Technical News Bulletin

Steinhausen, December 2007

FPS for Plunger Up – Performance Enhancement

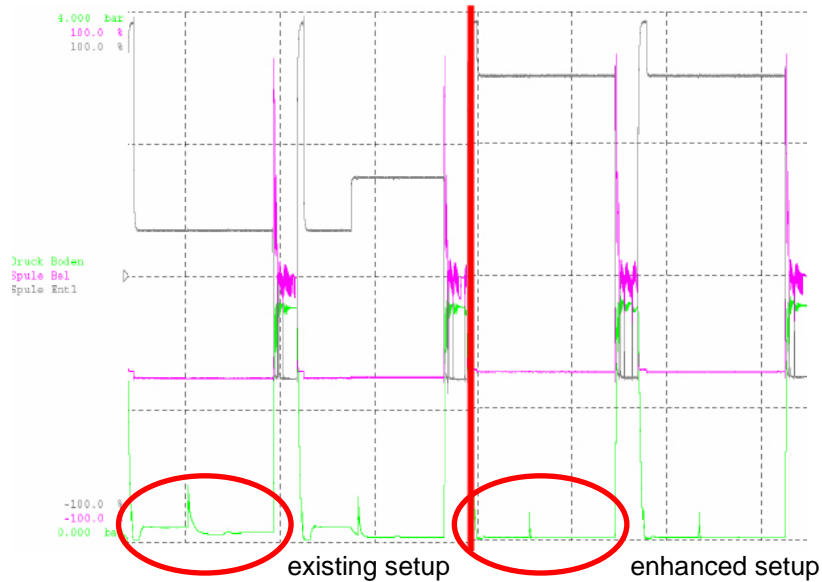
The performance in the Blow and Blow process as well as in Narrow Neck Press and Blow could be significantly improved due to optimized FPS valve parameter settings. This has been possible because of the features the new designed valves which introduced earlier this year (see TNB 122) provide.

The new ED07 valve setup as no impact in case this size of valve is used for Counter Blow/Plunger Cooling application and can be used as spare/replacement for any previous ED/ND07 FPS valve.

In Blow and Blow production the significant difference is the motion from the Counter Blow Position to the Down Position. The speed of the plunger movement from the **Counter Blow Position to the Down Position** will be much faster and more controllable as on the previous setup.

The motion from the **Down Position into the Up Position** and the motion from the **Up Position to the Counter Blow Position** will not be affected by the changes.

*Narrow Neck
Blow/Press
Production*

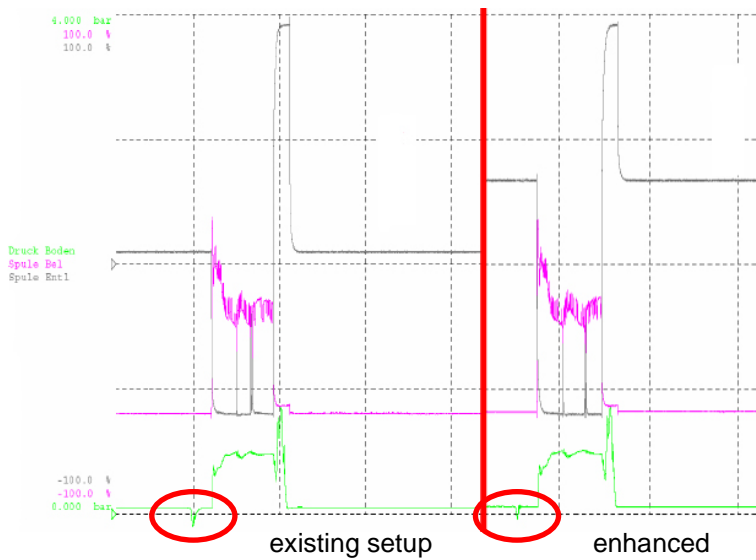
In Narrow Neck Press and Blow as well as Press and Blow the significant difference is the motion from the **Down Position to Loading Position**. The motion speed to the loading position and the precision of the loading position will be enhanced with the new setup. The **Pressing** and the **Down Motion** will remain unchanged.
